Planning Commission Staff Report

Project Type:	Site Development Section Plan
Meeting Date:	April 28, 2014
From:	Purvi Patel Project Planner
Location:	North of Chesterfield Parkway East, south of Interstate 64/US Highway 40 (SE Quadrant)
Applicant:	Stock and Associates Consulting Engineers, Inc., on behalf of Mercy Health Systems
Description:	<u>Mercy Health Systems (Virtual Care Center):</u> A Site Development Section Plan, Landscape Plan, Tree Preservation Plan, Lighting Plan, Architectural Elevations, Architect's Statement of Design, and Parking Demand Study for a 43.35 acre tract of land zoned "UC" Urban Core District located north of Chesterfield Parkway East, south of Interstate 64/US Highway 40 (SE Quadrant).

Figure 2: Preliminary Development Plan

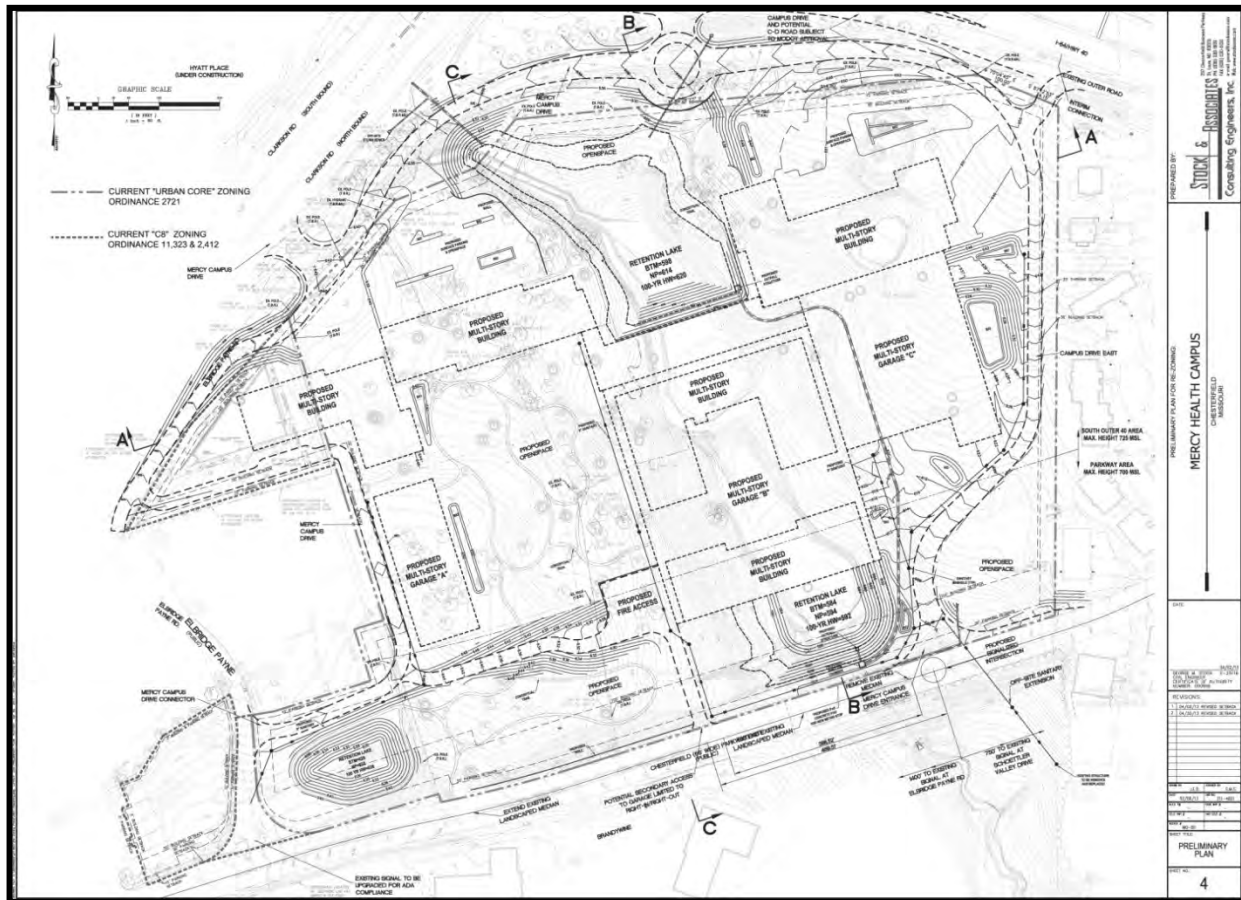
Furthermore, the proposal for the development of the Virtual Care Center, also known as Phase 1A of the Mercy development, substantially complies with the approved Preliminary Development Plan on file (see Figure 2 below).

Figure 3: Entrances to Site and Drop-off Area

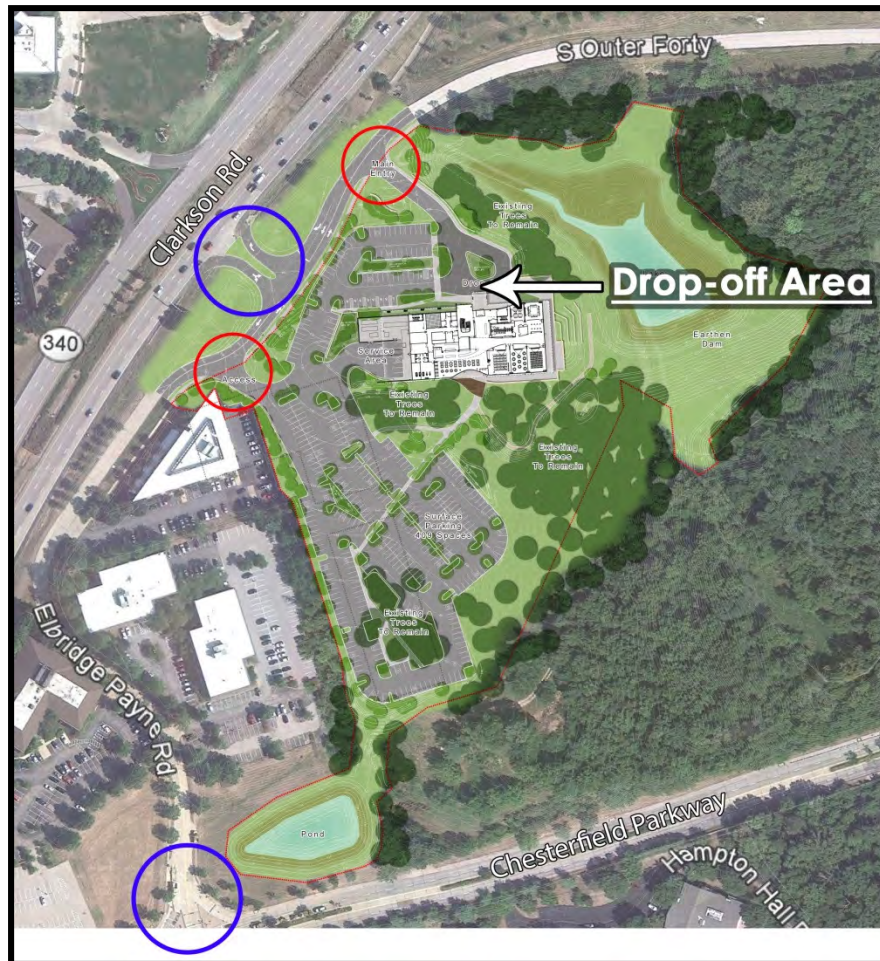
There are two (2) access points to the Mercy development currently (shown in blue on Figure 3): an entrance off Clarkson Road and a second entrance from Chesterfield Parkway East/Elbridge Payne Road. Once the Mercy site is accessed via one of these two (2) entrances, there are two (2) internal access points leading directly into the smaller Virtual Care Center site within the overall Mercy site. These access points are shown in red in Figure 3 below.

A landscaped drop-off area is proposed off of the easternmost entrance to the site in order to provide a clear arrival point for visitors to the building. The employee and service entrance is located near the northwestern portion of the site off of Elbridge Payne Road.
